DRESDEN NUCLEAR POWER STATION UNIT NO. 2

AMENDMENT TO PROVISIONAL OPERATING LICENSE

Amendment No. 58  
License No. DPR-19

ATTACHMENT TO LICENSE AMENDMENT NO. 58

Figure 3-4  
MAXIMUM AVERAGE PLANT LINEAR HEAT GENERATION RATE (KW/FT)  
(Sheet 1 of 5)

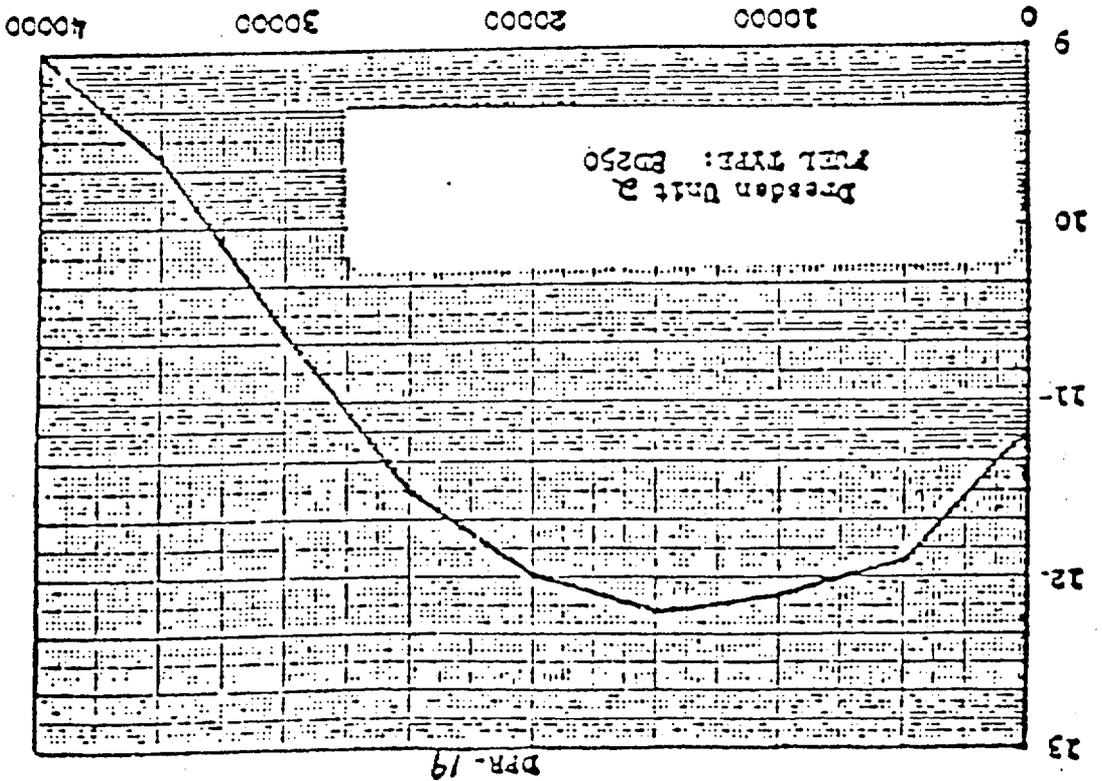
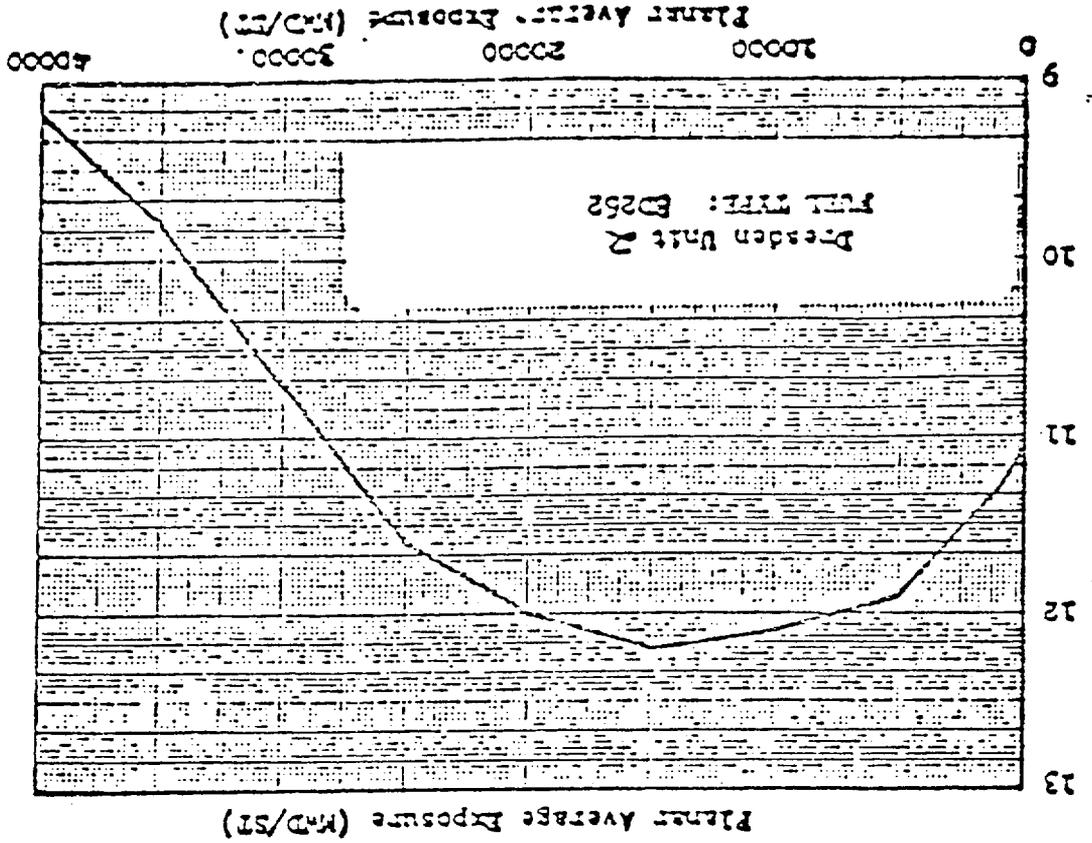
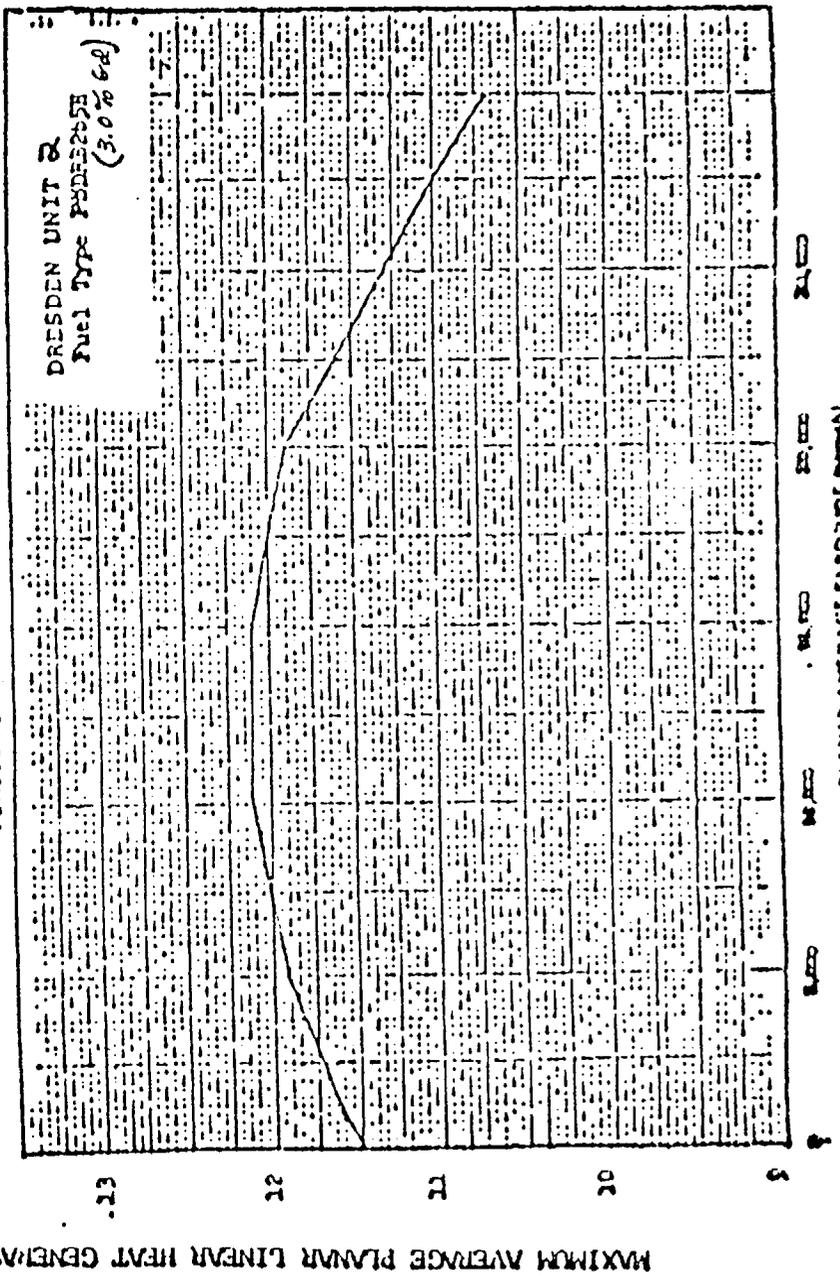
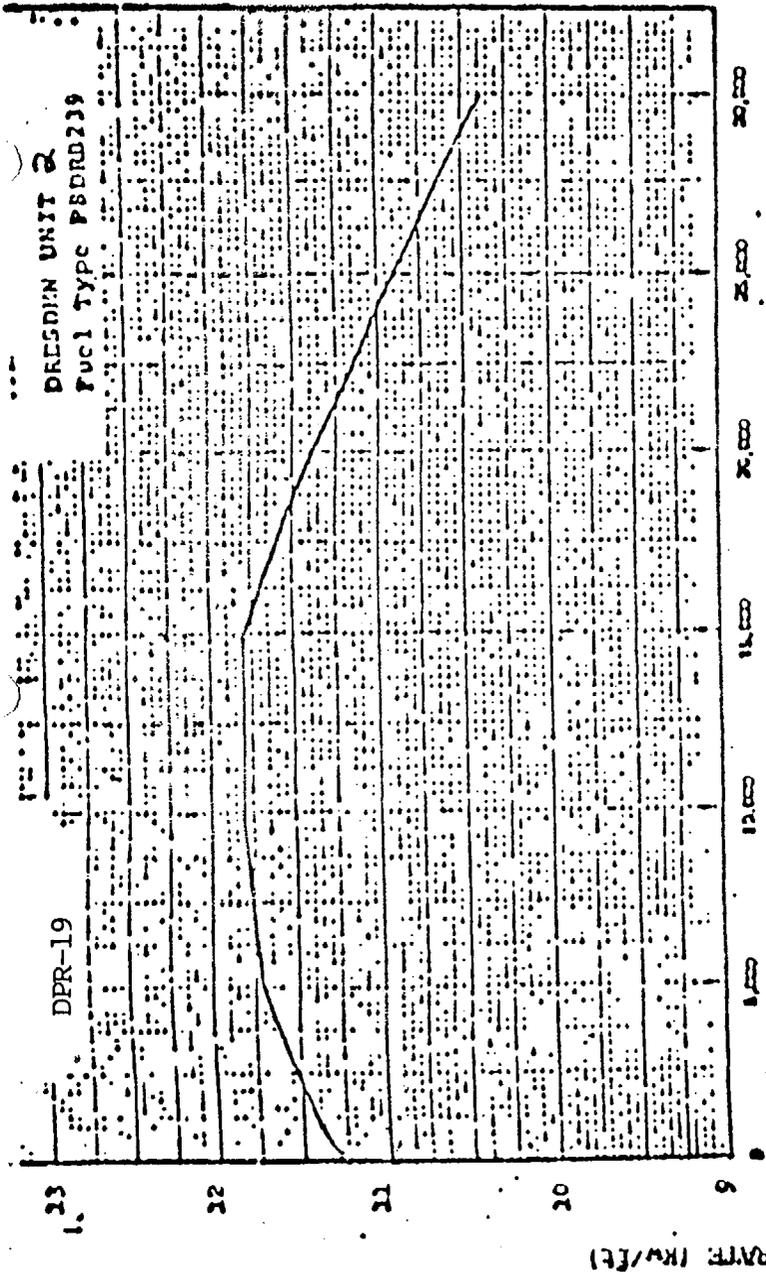
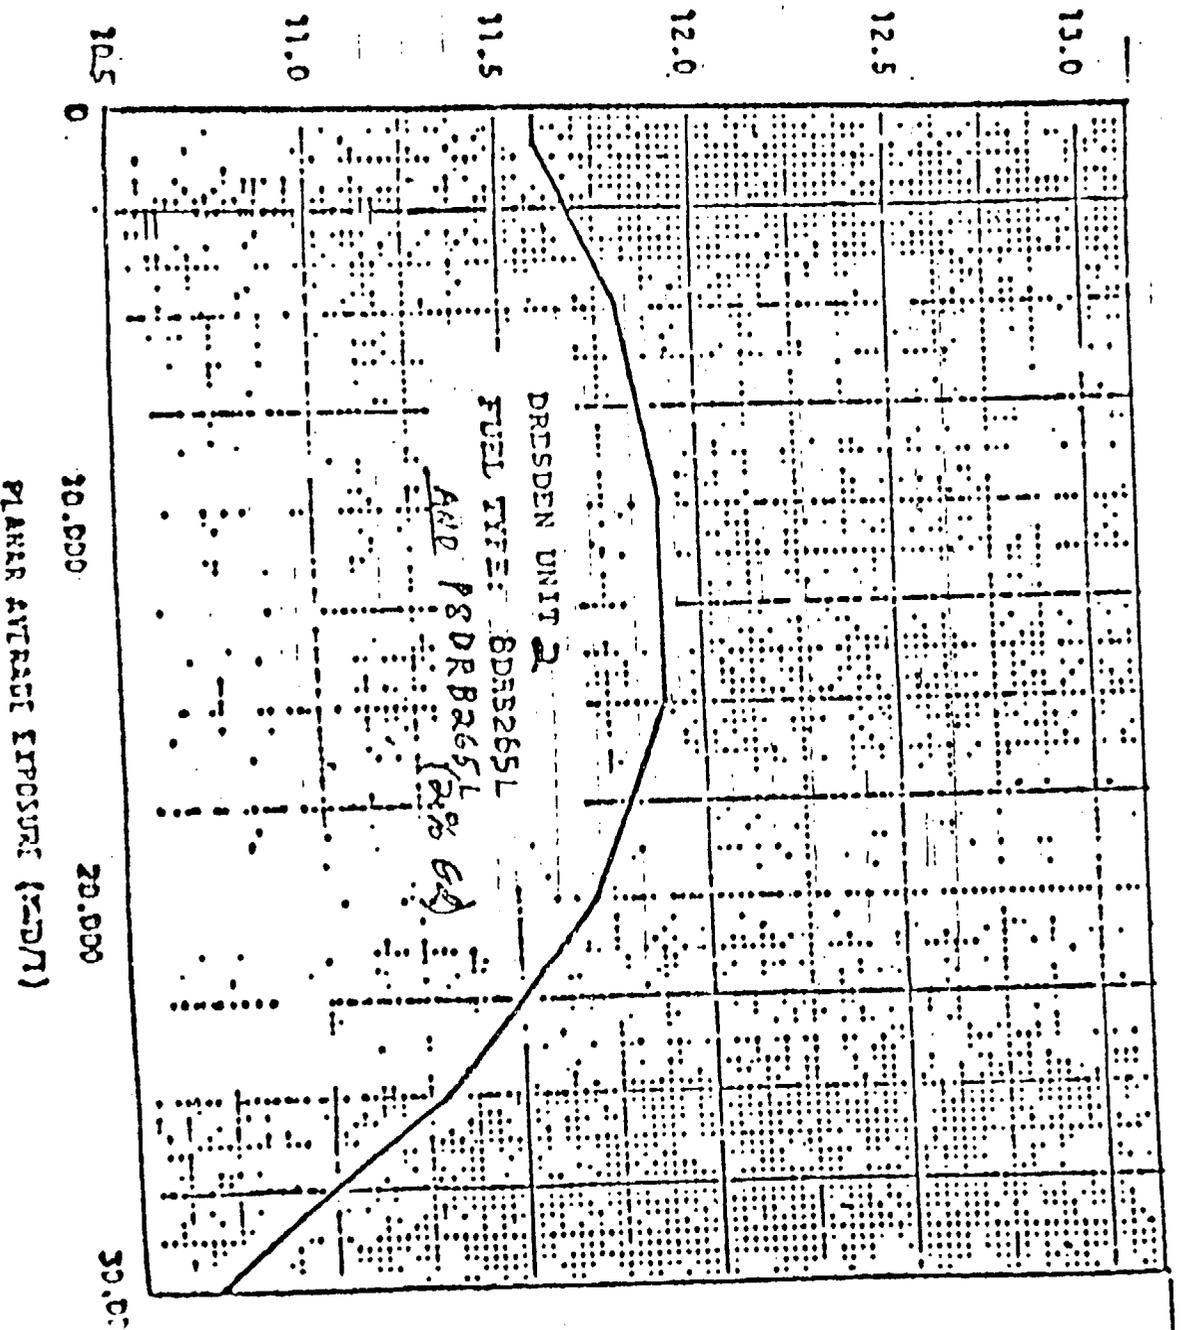
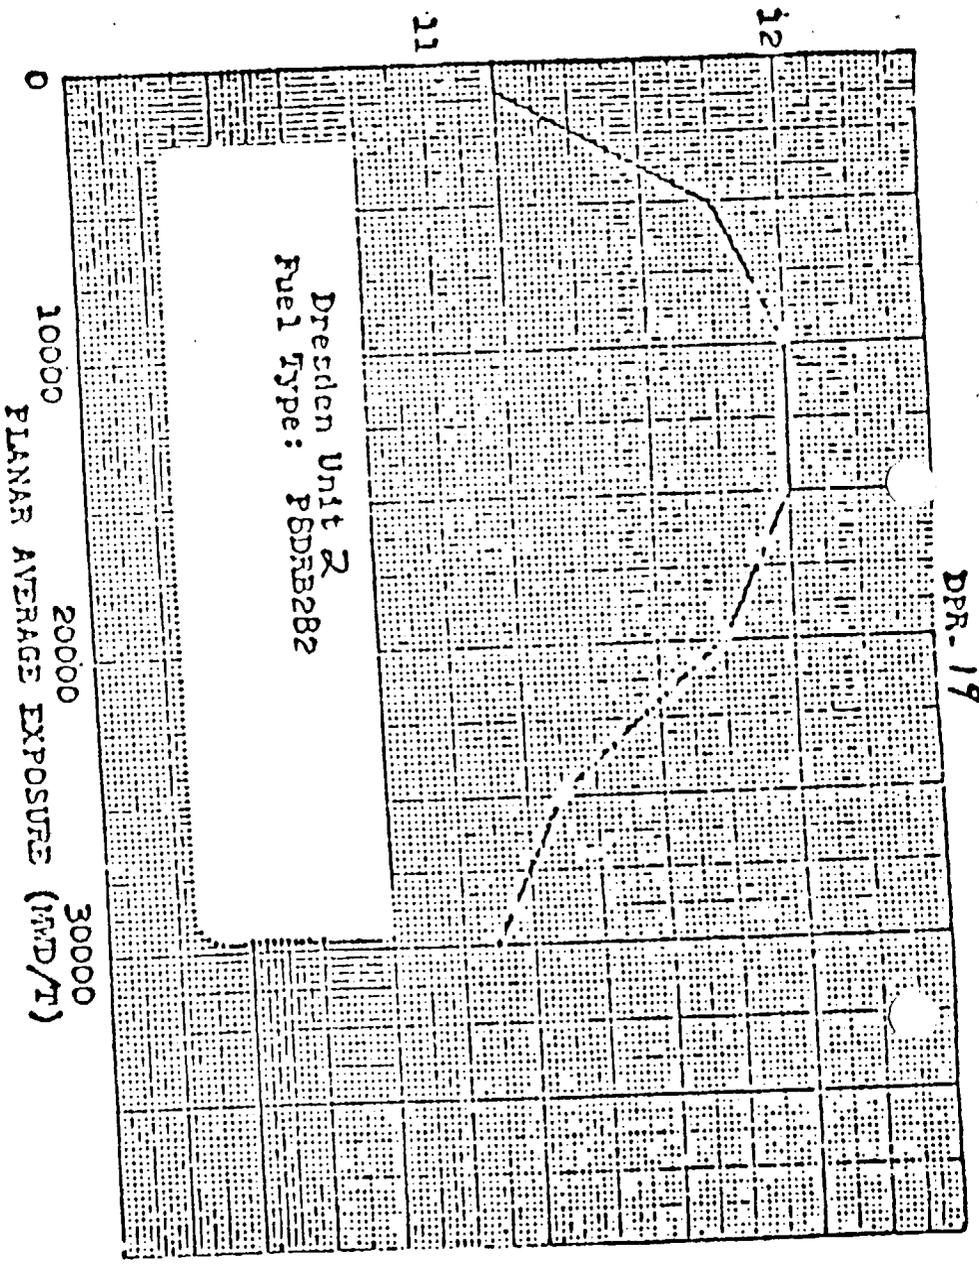
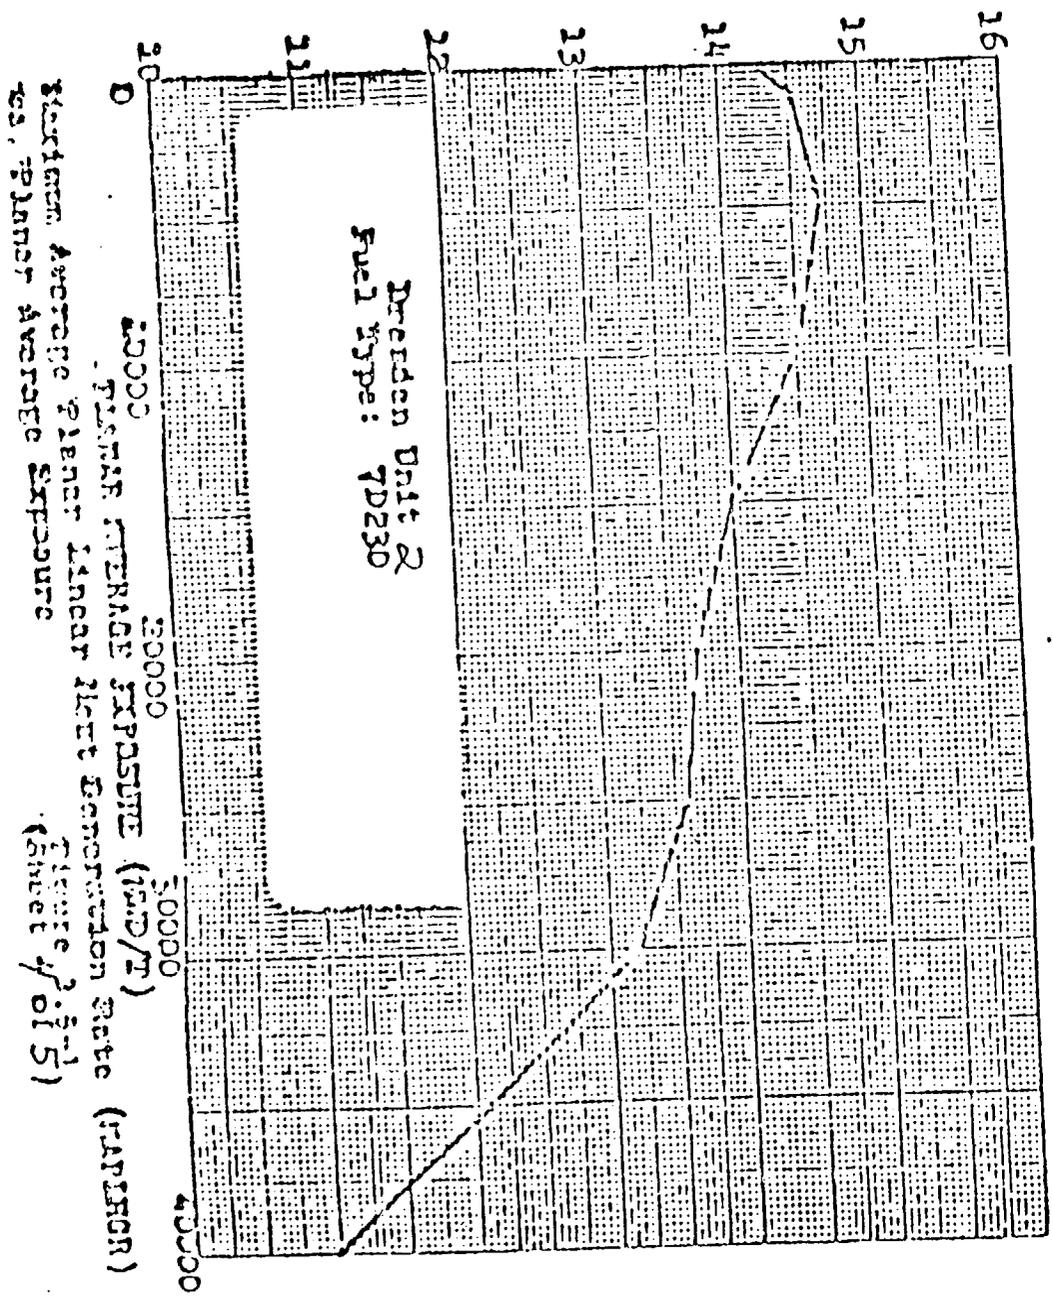
The maximum average planar INGR shown in Figure 3.5.1 are based on calculations employing the models described in Reference (1). Power operation with INGRs at or below those shown in Fig. 3.5.1 assures that the peak cladding temperature following a postulated loss-of-coolant accident will not exceed the 2200°F limit. These values represent limits for operation to ensure conformance with ICCRSO and Appendix K only if they are more limiting than other design parameters.

The maximum average planar INGRs plotted in a Fig. 3.5.1 at higher exposures result in a calculated peak clad temperature of less than 2200°F. However the maximum average planar INGRs are shown on Fig. 3.5.1 as limits because conformance calculations have not been performed to justify operation at INGRs in excess of those shown.
